**TOWN OF NEWBURGH
PLANNING BOARD
TECHNICAL REVIEW COMMENTS**

PROJECT: GARDNERTOWN COMMONS
PROJECT NO.: 2016-03
PROJECT LOCATION: SECTION 75, BLOCK 1, LOT 21
REVIEW DATE: 28 APRIL 2017
MEETING DATE: 4 MAY 2017
PROJECT REPRESENTATIVE: JCM PLANNING ENGINEERING

RE: JMC Project 15155
 Gardnertown Commons
 Gardnertown Road
 Town of Newburgh, NY

Scale: NOT TO SCALE
Date: 02/19/2016
Project No: 15155
Drawing No: DET 4
SP-14

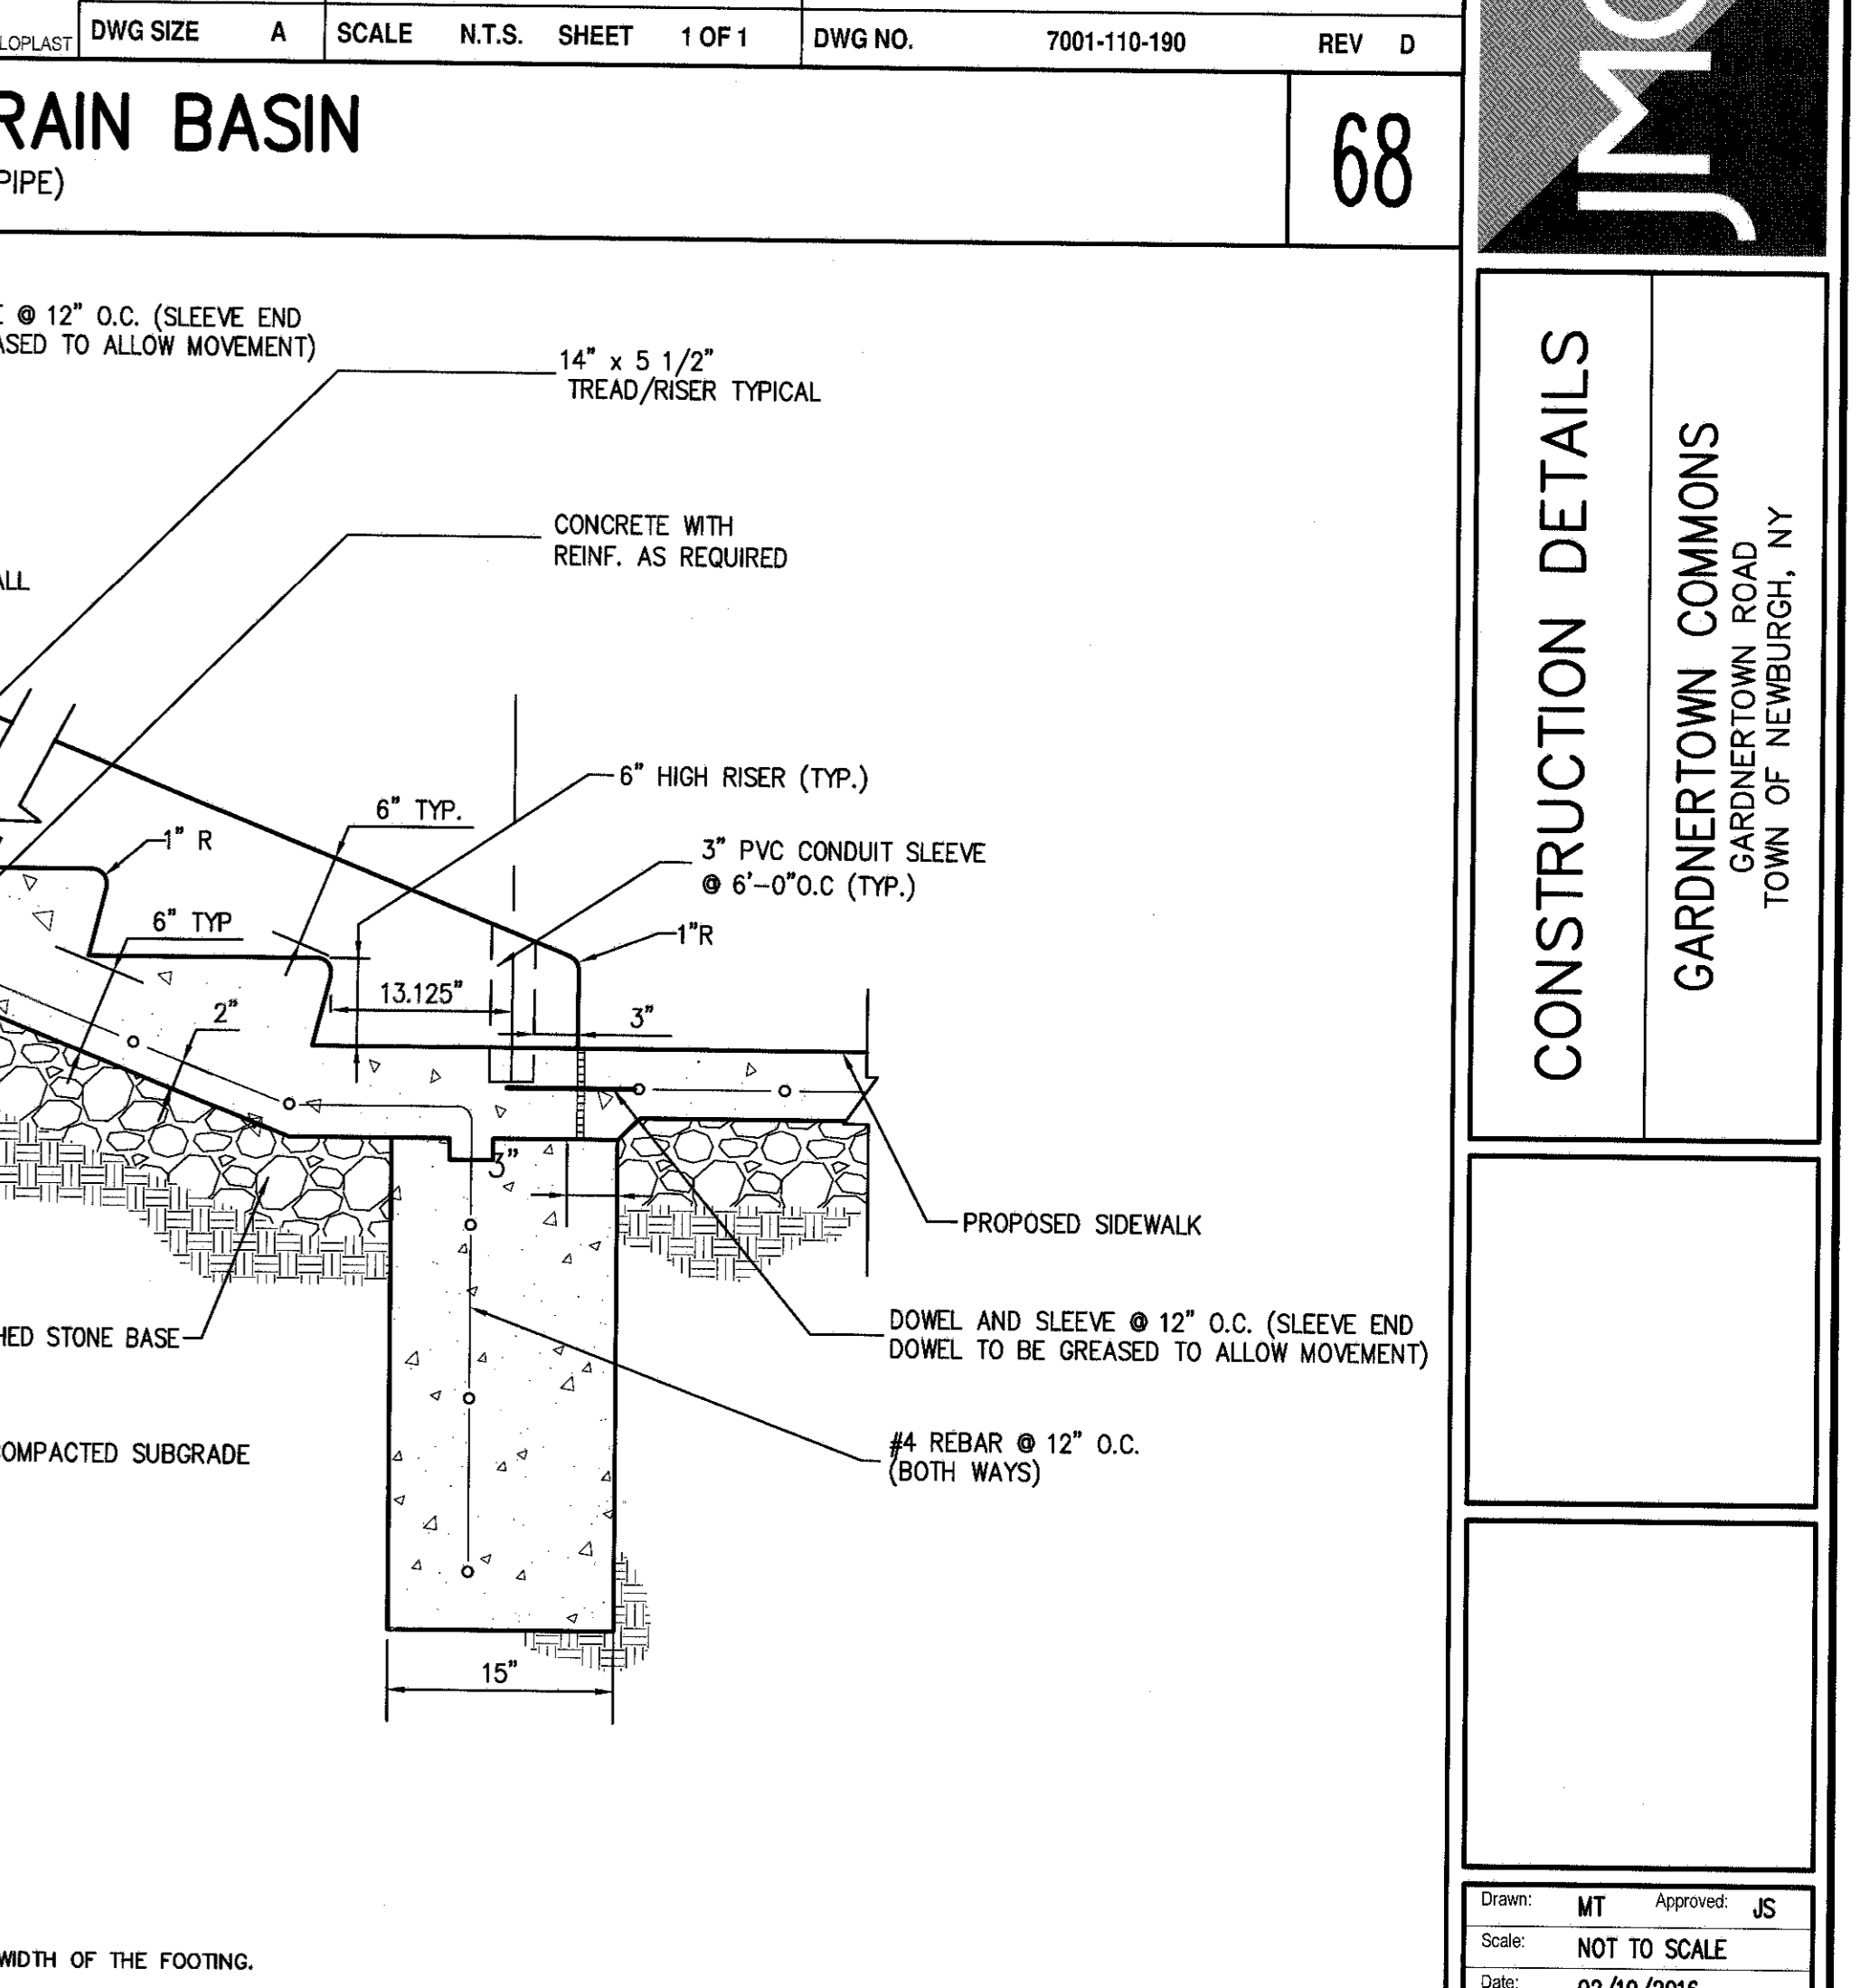
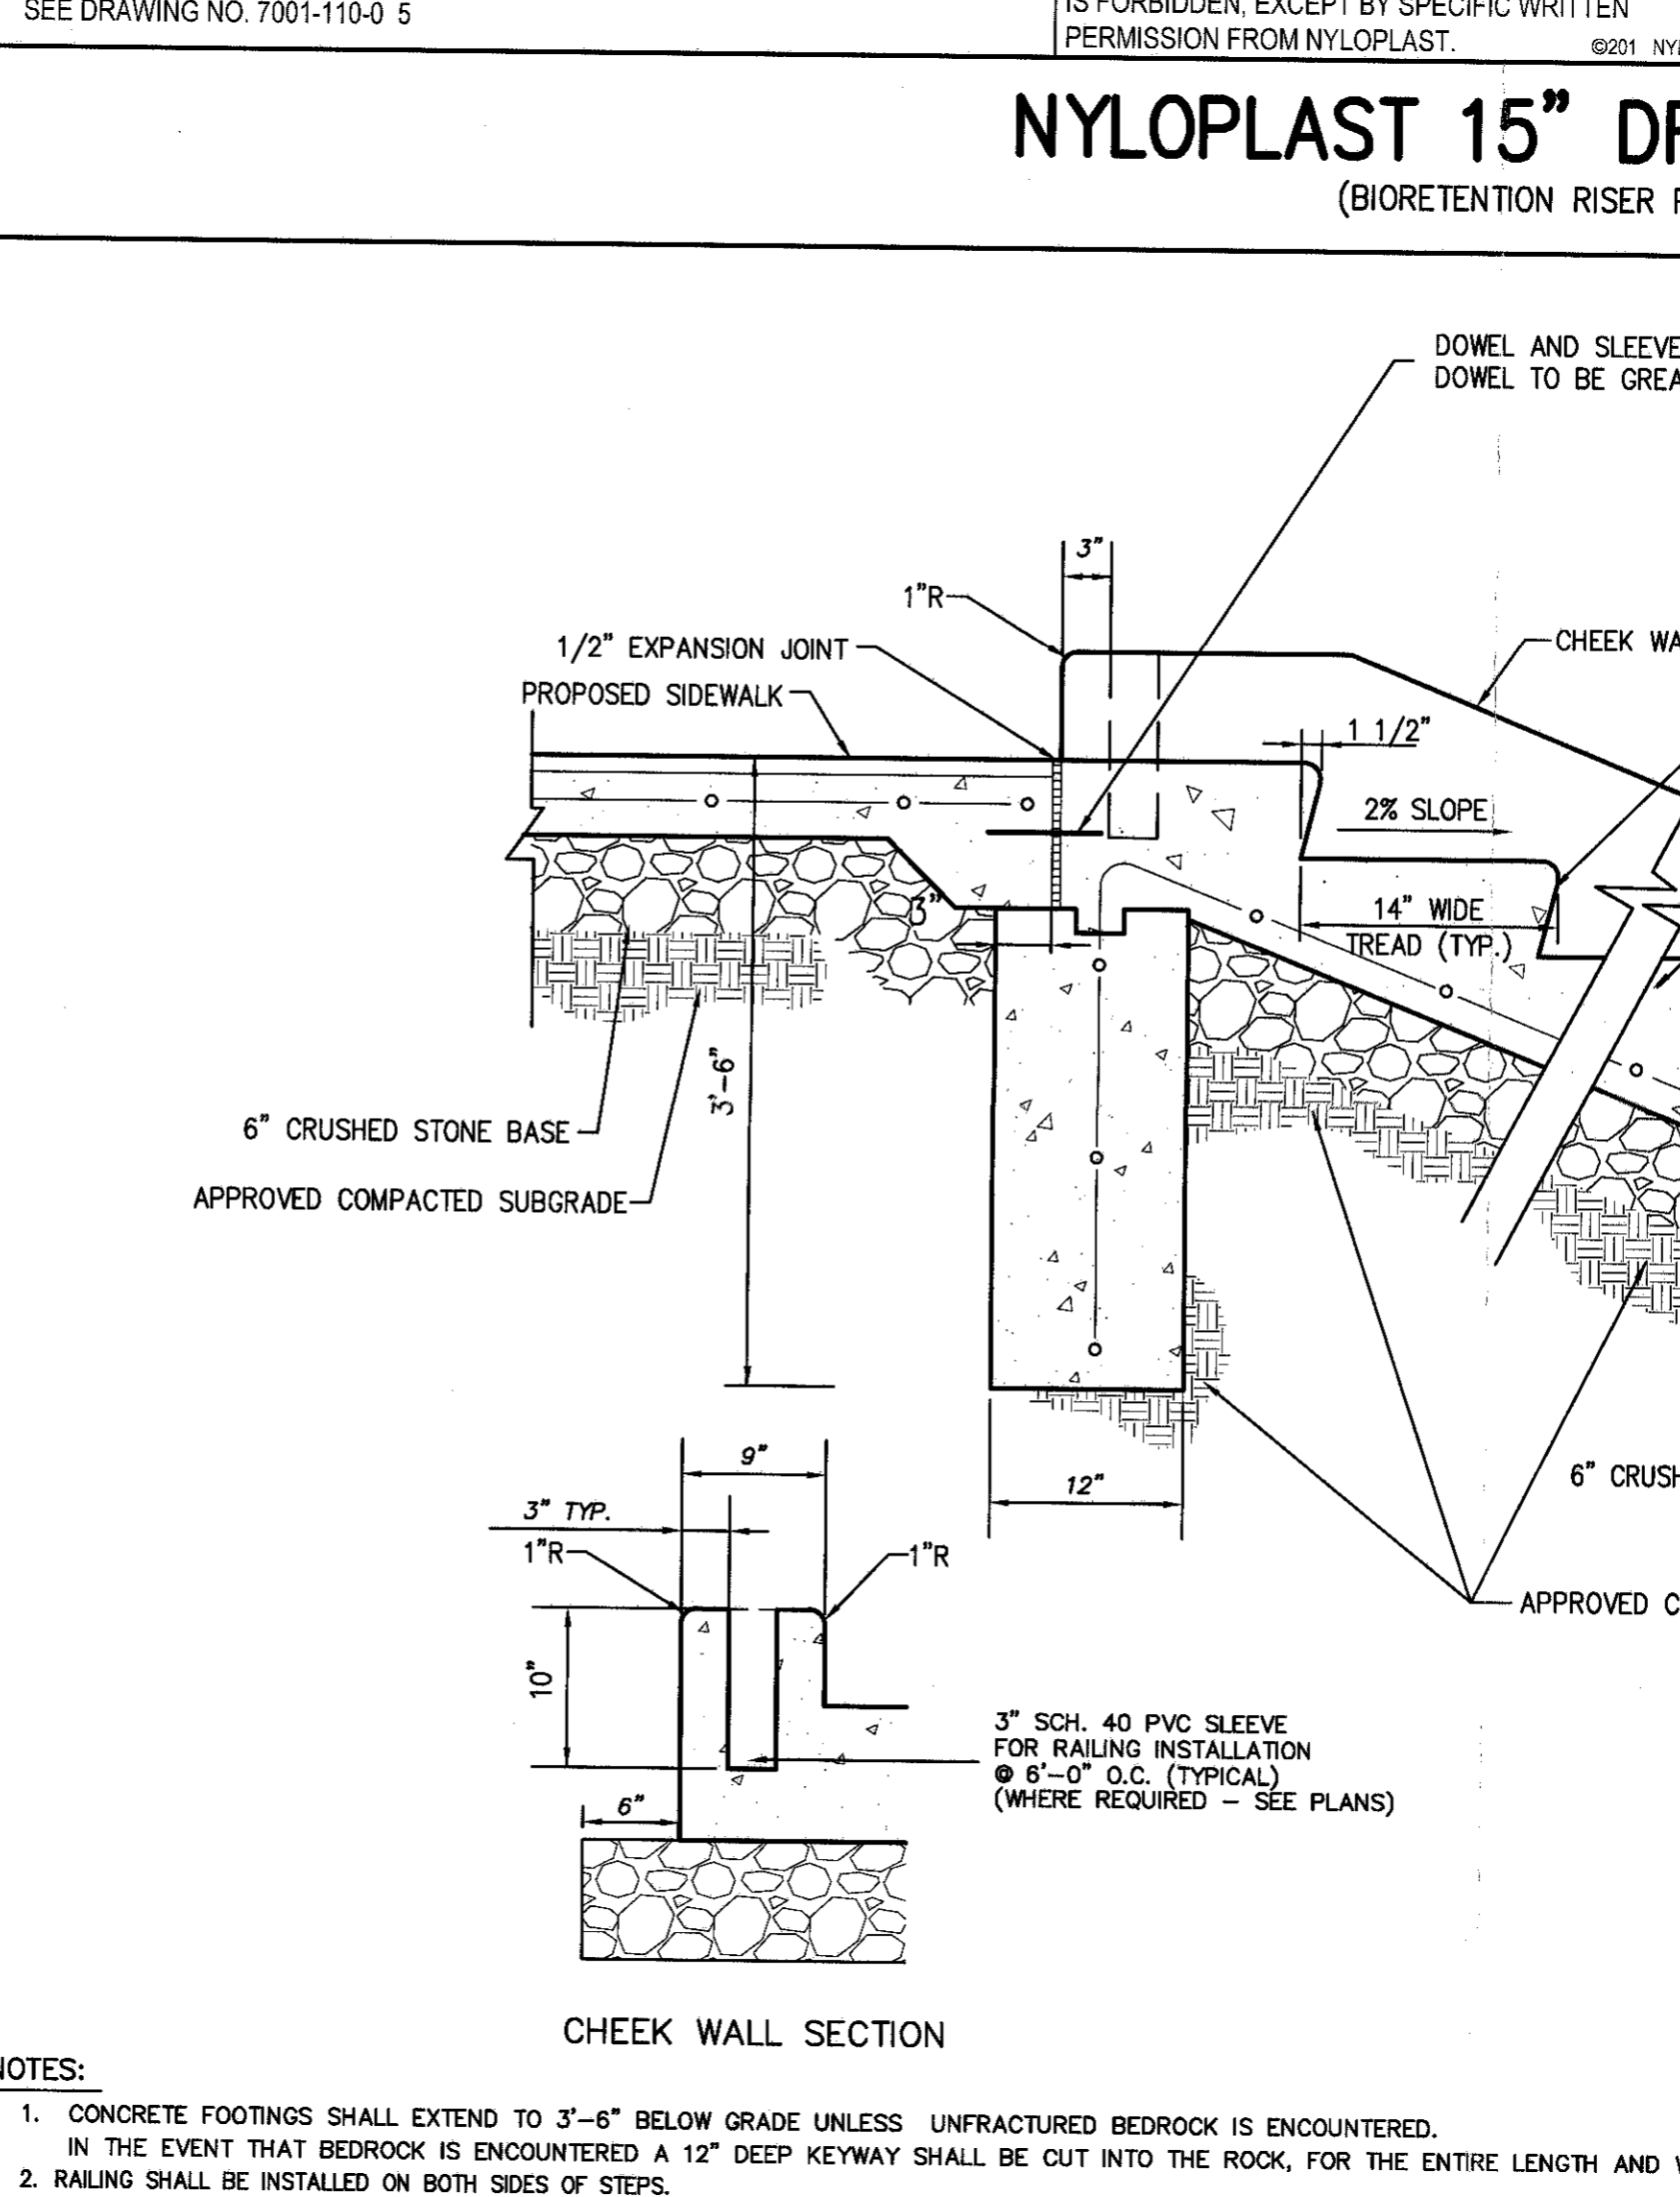
Extensive retaining walls have been proposed based on modified grading on the site. Vehicle protection and fencing must be depicted on the details.

Detail #42 on page SP-14 has been added to depict the layout of the retaining wall, guide rail, and fence in relation to one another. In addition the site layout plan has been revised to show the relocated lights and guide rail and fence locations.
